Re: Case Number P&Z 21-181

In response to comments raised during the May 4, 2023, Planning Board hearing, Eversource wishes to provide you with the following update.

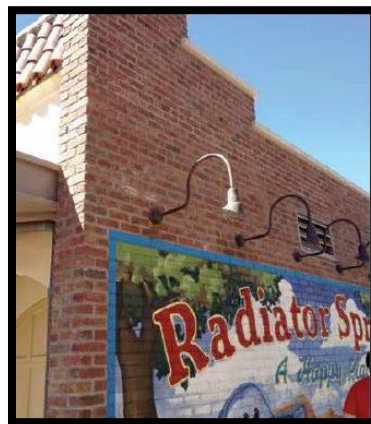
**2. Request that dimensional bricks, rather than veneer bricks, be used on the proposed screening wall's projecting pilasters**

Planning staff, per their 04/26/2023 memo, recommended that the "screening around the new proposed transformer incorporate architectural brick materiality on the projecting pilasters", while the Planning Board, at its 05/04/2023 public hearing, suggested the use of dimensional brick for the entire enclosure around the new transformer.

To ensure the design provides for the required accessibility to our equipment for operations and maintenance, the Prospect Street side of the walled enclosure must have removable columns/pilasters and wall sections. By having removable pilasters and wall sections the third transformer and other larger pieces of equipment can be easily repaired or even removed and replaced, which in turn allows for faster service restoration and limits the potential duration of any outages.

The removable wall sections and pilasters will be precast concrete and will be manufactured by the same company responsible for creating the other two (non-removable) sides of the walled enclosure. Eversource's intention would be to apply a brick paneling system to both the wall sections and pilasters on the Prospect side of the walled enclosure. Door openings, space for art installations, and other details can be incorporated into the design.
